CA 94-05 White, William  
Bldg. Permit

STATE OF MARYLAND  
CRITICAL AREA COMMISSION  
CHESAPEAKE AND ATLANTIC COASTAL BAYS

February 9, 2005

Re: Modification to Building and Grading Permit-White Property

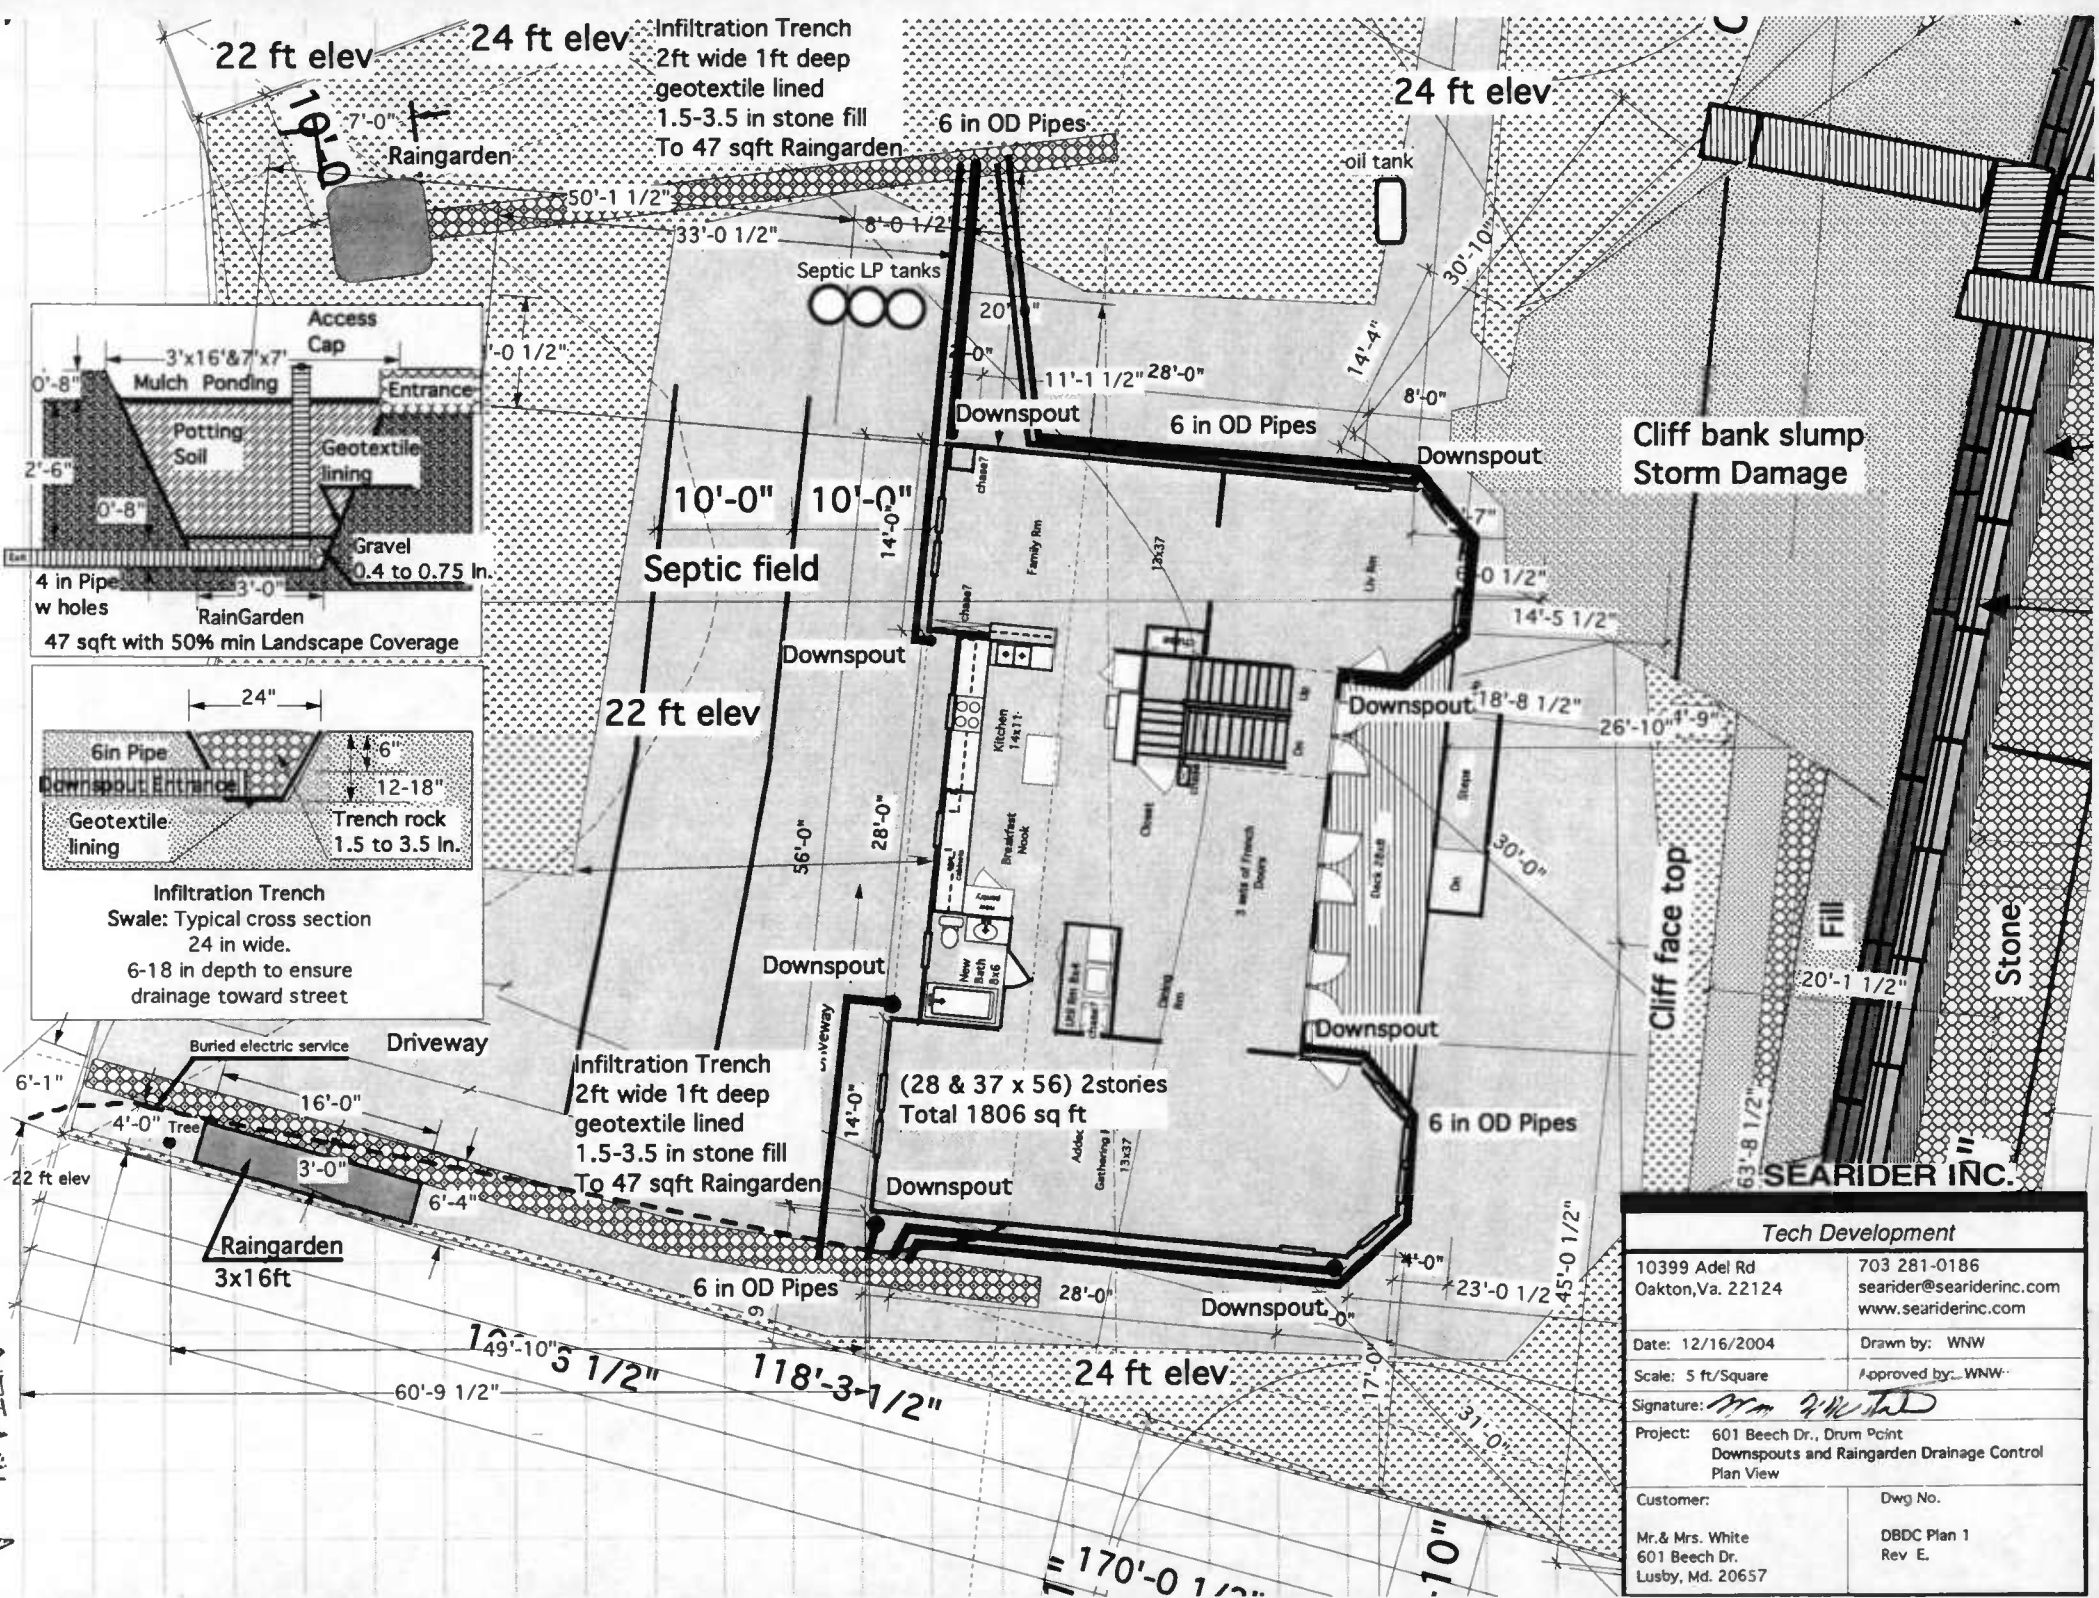
In order to stabilize the face of the cliff and to provide for effective stormwater management on the property, it is my understanding that the applicant intends to remove the current connection to the downspouts located at the rear of the house. These downspouts will be reconnected to a PVC pipe that directs rooftop runoff to rainwater trenches located on either side of the house, and ultimately outfalls to a series of rain gardens located on the front or street side of the property. In addition, a retaining wall and section of revetment will be installed to stabilize the eroding cliff face.

Per the conditions included within the County's approval of the revised building and grading permit, I understand that proposed modifications on the property will be conducted in phases and that the downspout connections and stormwater management measures will be completed and inspected by the County prior to beginning work on the retaining wall. In addition, we note that the restored area above the retaining wall is to be planted in vegetative cover as a condition of approval.
